Field Report

Project	Residential Structural Observation	Project No.	23-F025
Location	1185 Joe Collins Rd Lillington, NC 27546	Report No.	1
Client	Eunice Bucur	Day & Date	Tuesday, 04.18.23
Contact	eunicebucur@gmail.com	On-Site Time	1.00 hr
		Report Prep.	3.00 hr
		Travel Time	2.00 hr
		Total	6.00 hr

I arrived on site, as requested, to perform a Structural observation in accordance with 2018 North Carolina State Residential Code. This observation pertains to existing LVL framing and other framing concerns raised by an AHJ inspection. Structural Observation does not include or waive the responsibility for the inspections required by other sections of the building code.

BASEMENT PLAN

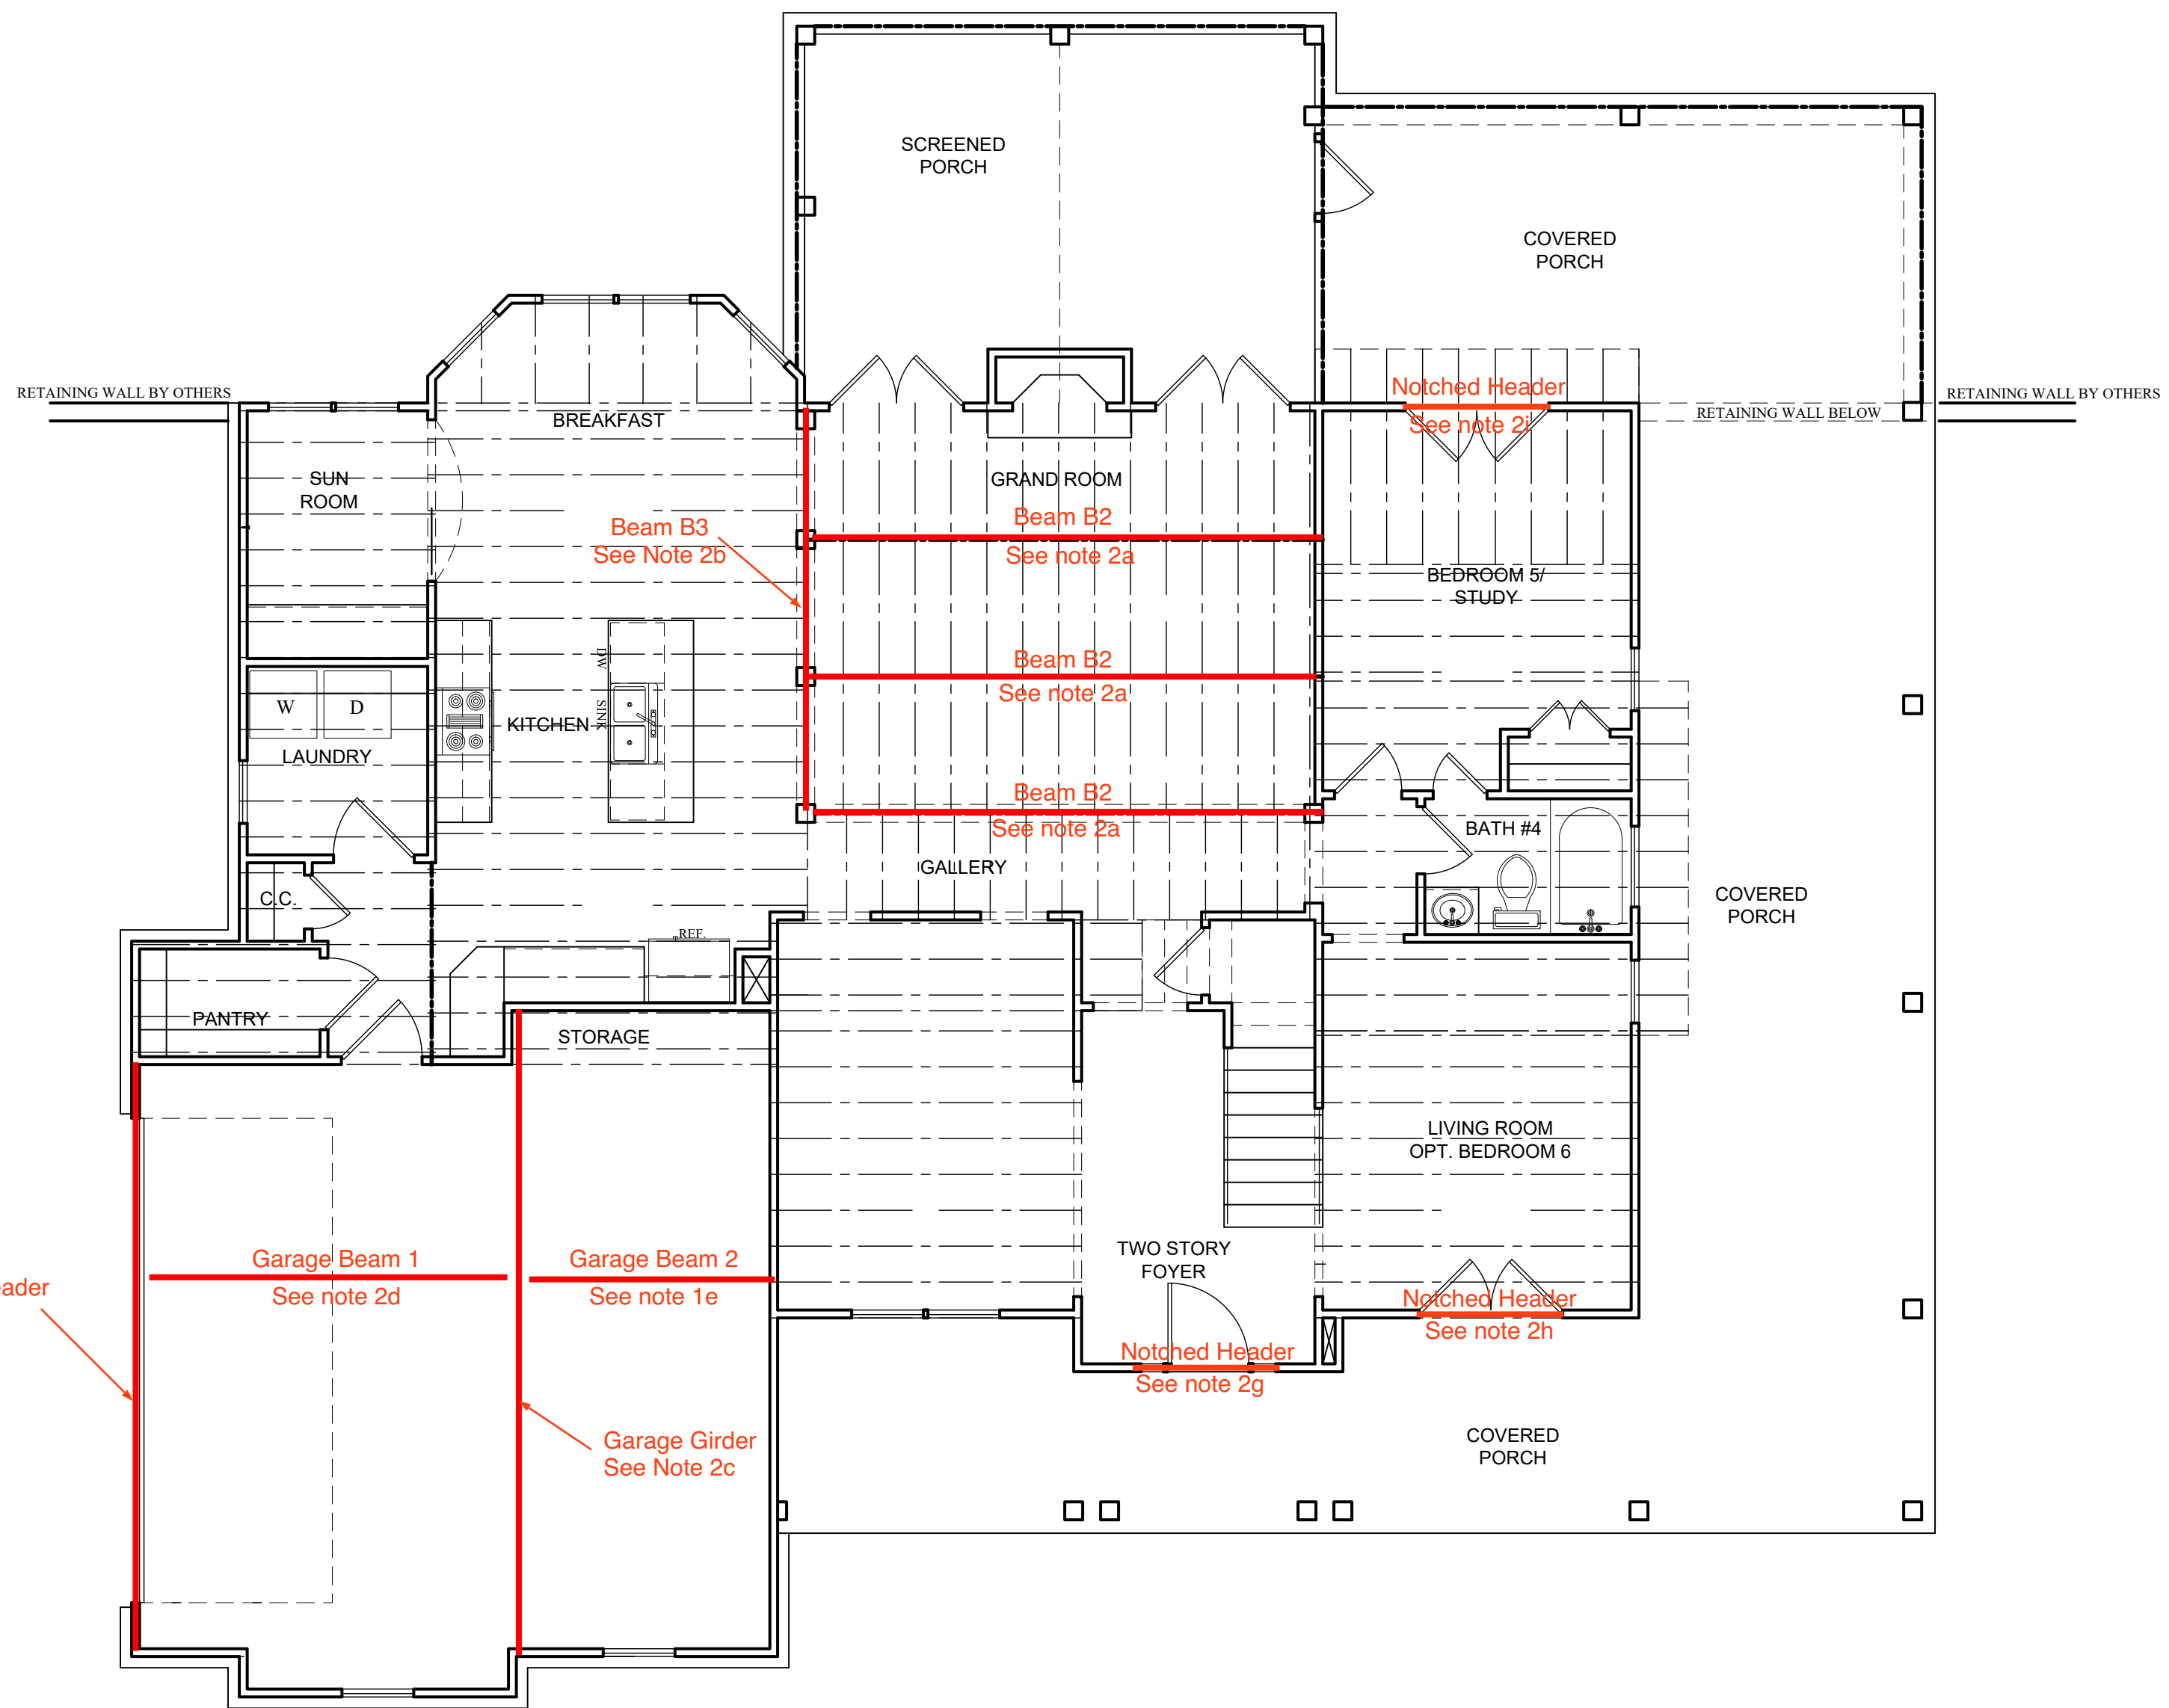
1- Basement Level

- a. Beam B1 = 3-ply 16" LVL supported by minimum 4 ~ 2 x 4 jack studs each end.
- b. Attach double PT 2 x 12 deck joists on either side of the cantilevered chimney to the ledger with Simpson Strong Tie "LS50" angle, using 4 ~ 8d x 1½" nails into the ledger and 4 ~ 8d common nails into the double joist.
- c. Notched joists to allow plumbing penetration shall be acceptable as observed. No additional repair shall be required.
- d. Observed toenailed connection between header and floor joist by plumbing penetrations shall be adequate.

FIRST FLOOR PLAN

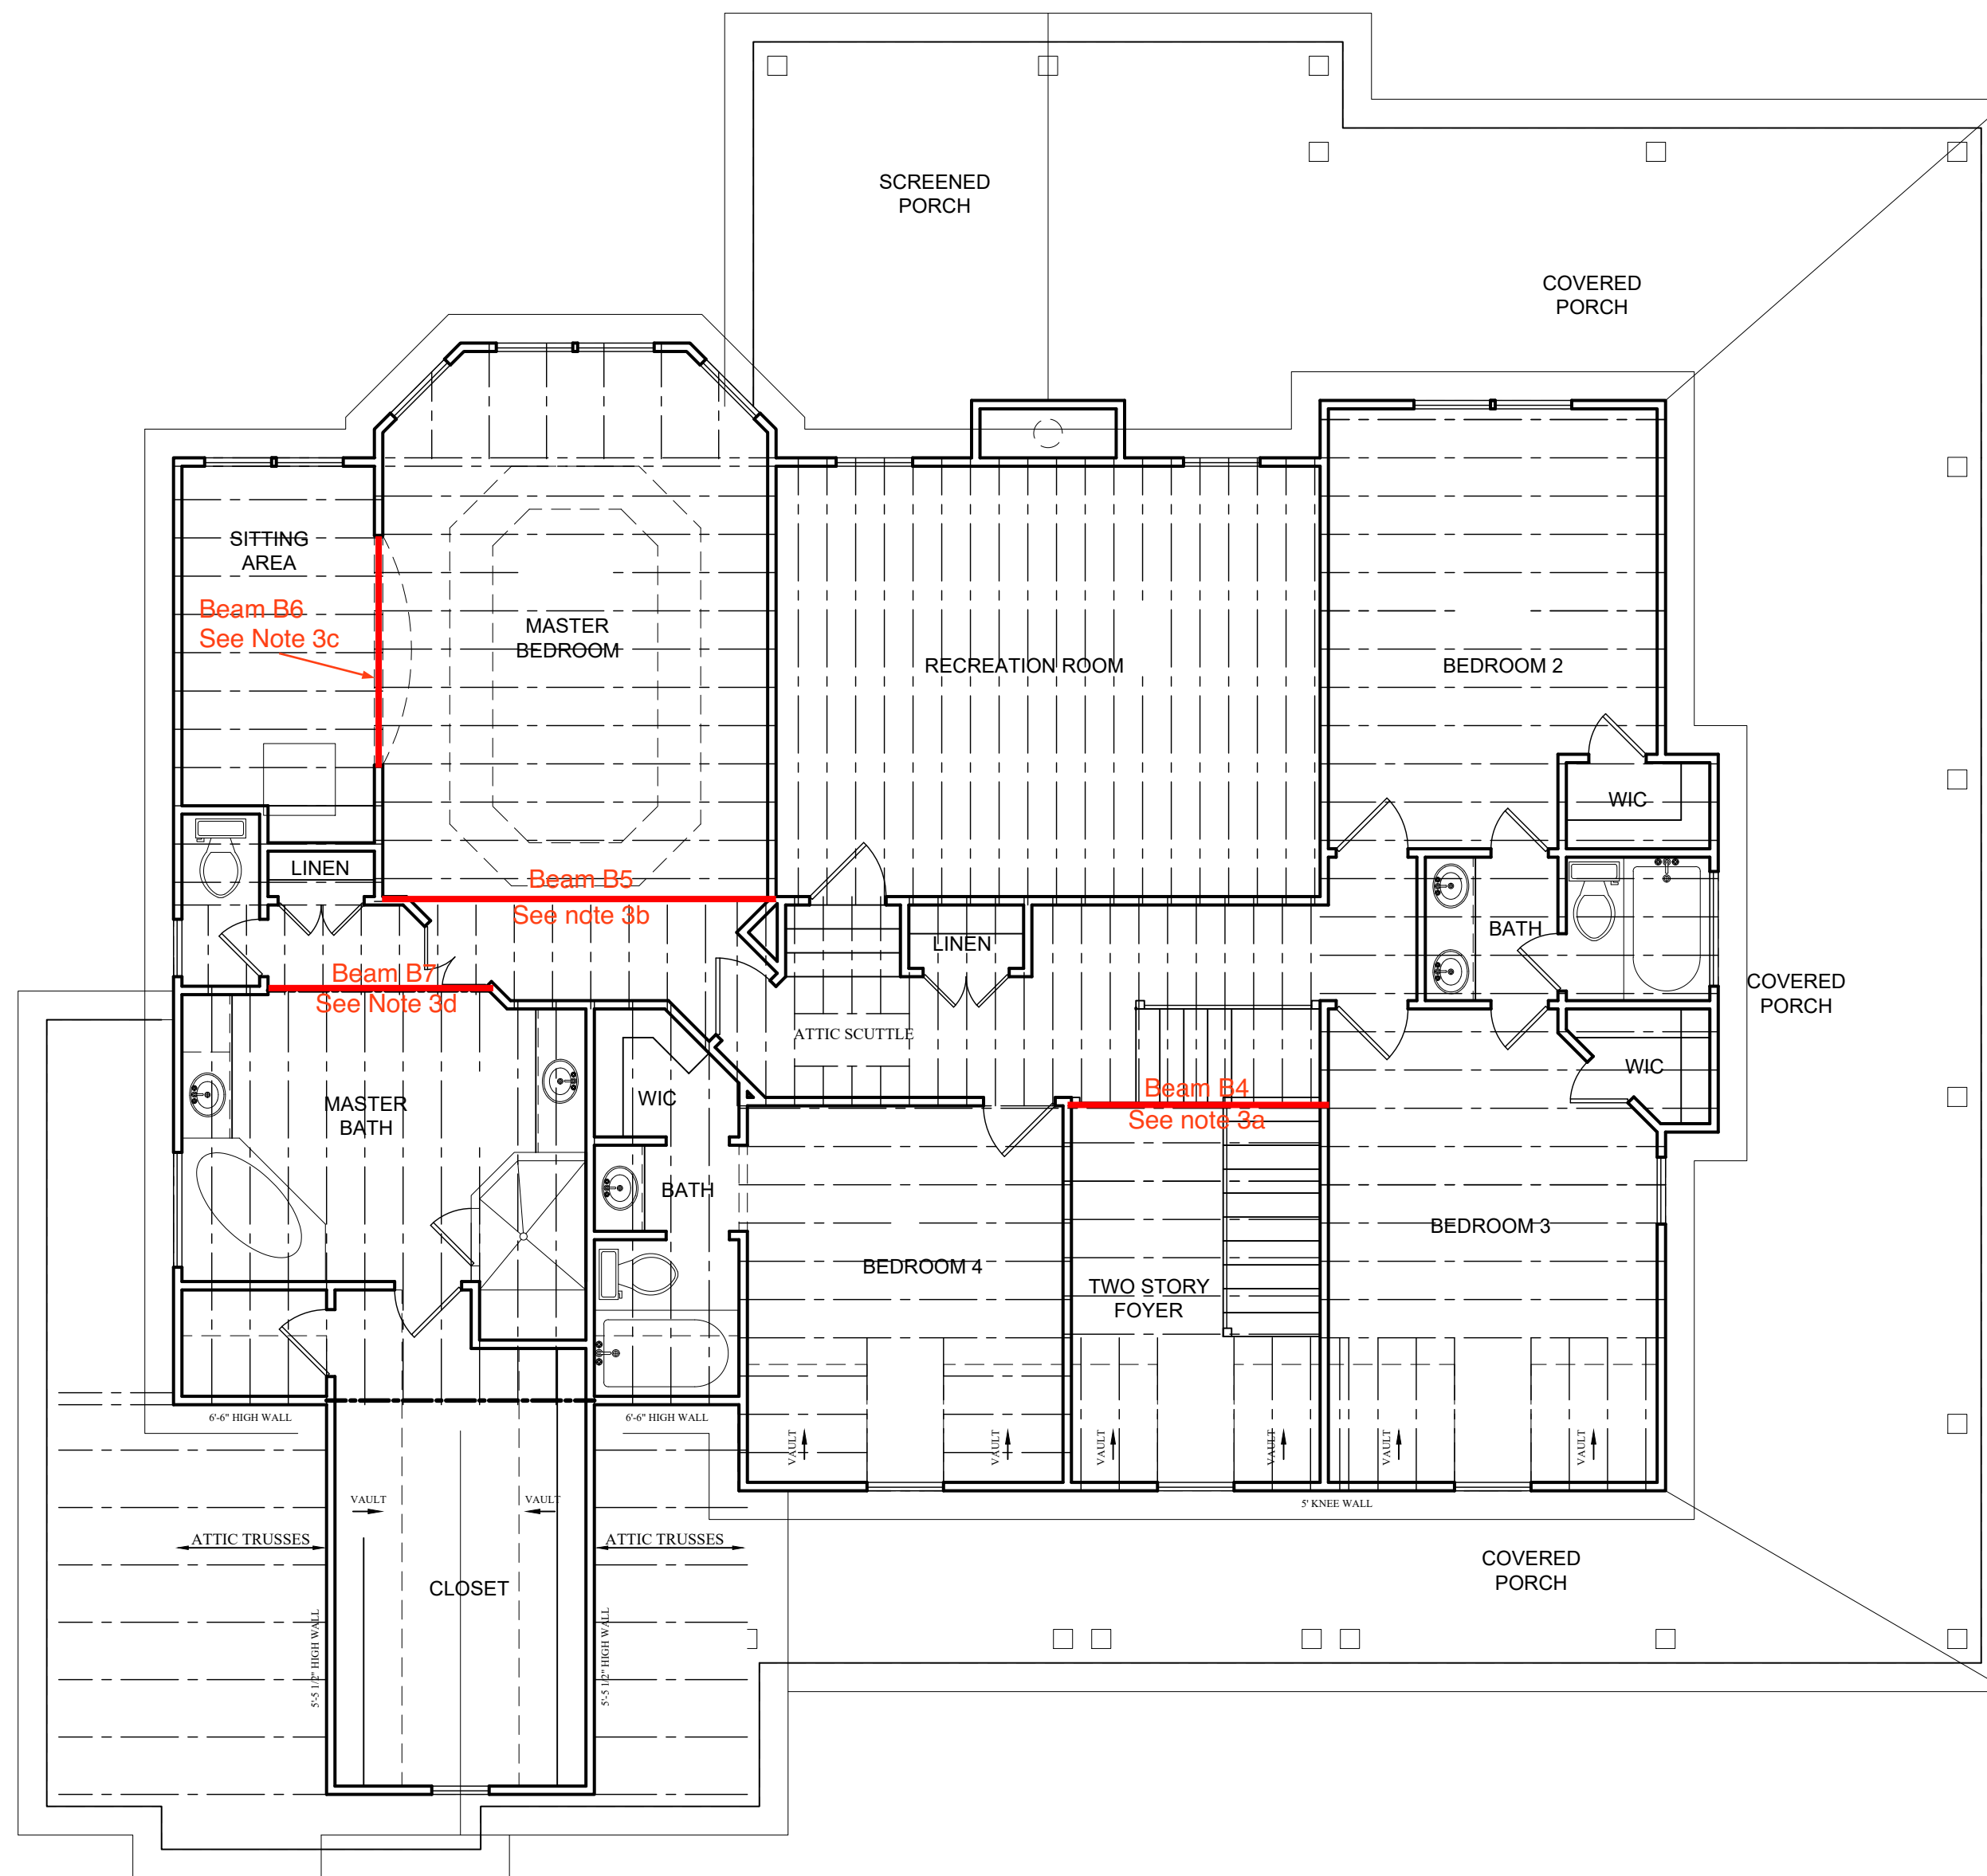
2- First Floor Plan

- a. Beam B2 = 4-ply 11⅞" LVL supported by minimum 4 ~ 2 x 4 jack studs each end.
- b. Beam B3 = 4-ply 11⅞" LVL supported by minimum 5 ~ 2 x 4 jack studs at one end and 4 ~ 2 x 8 jack studs on the other end..
- c. Garage girder = 3-ply 24" LVL supported by minimum 4 ~ 2 x 4 jack studs each end.
- d. Garage Beam 1 = 3-ply 9¼" LVL supported by minimum 4 ~ 2 x 4 jack studs at one end and Simpson Strong Tie "HU610" face-mount hanger at supporting 24" LVL.
- e. Garage Beam 2 = 2-ply 9¼" LVL supported by minimum 3 ~ 2 x 4 jack studs at one

- end and Simpson Strong Tie “HU410” face-mount hanger at supporting 24” LVL.
- f. Garage door header = 2-ply 24” LVL supported by minimum 3 ~ 2 x 4 and 4 ~ 2 x 4 jack studs (7 ~ total) each end.
- g. Notched header at 2-story foyer shall be acceptable as observed. No additional repair shall be required.
- h. Notched header at Living Room/Optional Bedroom 6 shall be acceptable as observed. No additional repair shall be required.
- i. Notched header at Bedroom 5/Study shall be acceptable as observed. No additional repair shall be required.
